**Bayside Local Planning Panel - Other Applications**

5.1 S82-2024/3 - 1015-1019 Botany Road Mascot - Section 8.2 Review.....2

5.2 DA-2024/52 - 228 The Grand Parade, Monterey - Development  
Application.....132

## Planning Assessment Report

Figure 3. Proposed Internal East and West Elevations

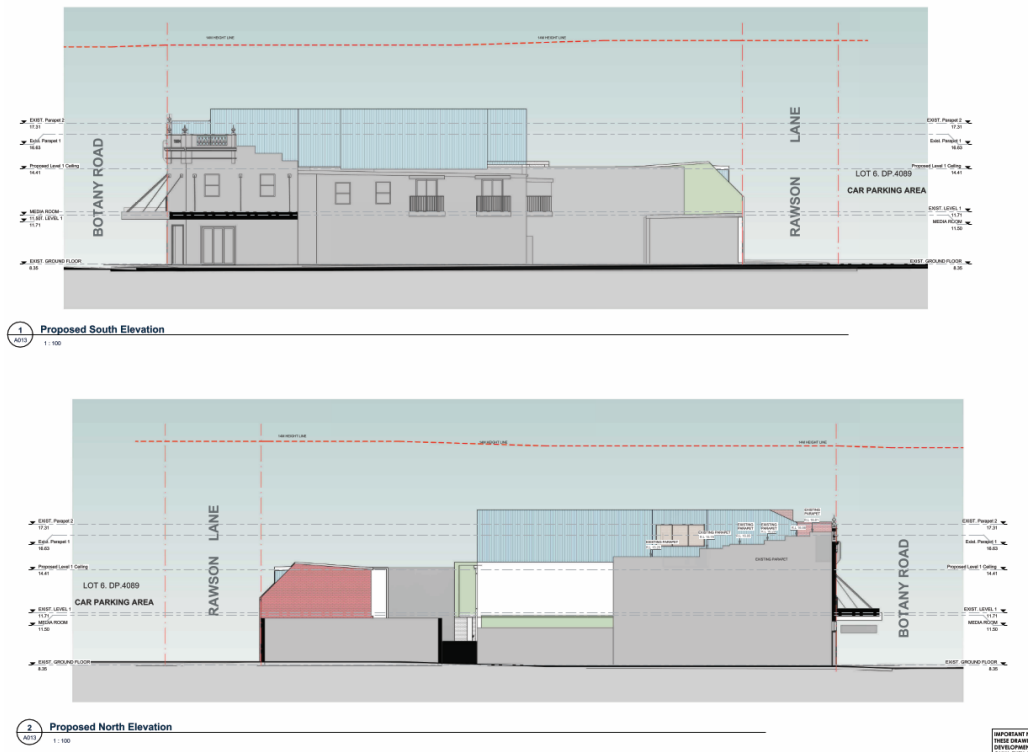
The additional third storey in the revised design contributes to further adverse impact on the heritage item. The third storey, with metal sheeting cladding and contemporary roof form, extends higher than the front parapet and will be visible from the intersection of Botany Road and Rawson Road, Rawson Road and Rawson Lane. It is uncomplimentary to the existing building and will alter the scale and form of the three shops, eroding the integrity of the extended row of shops. This additional storey will result in unacceptable level of heritage impact and was not supported by Council's Heritage Advisor.

Figure 13. Proposed shadow diagrams – Spring / Equinox

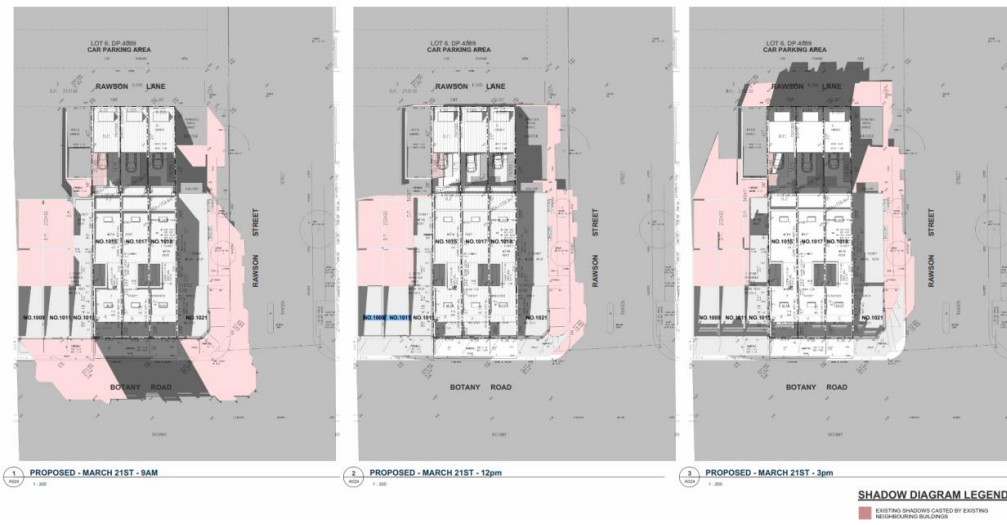
- i. E1 Local Centre - The proposal is not compatible with the existing streetscape and has adverse amenity impacts on residential amenity including visual bulk, solar access and visual privacy.
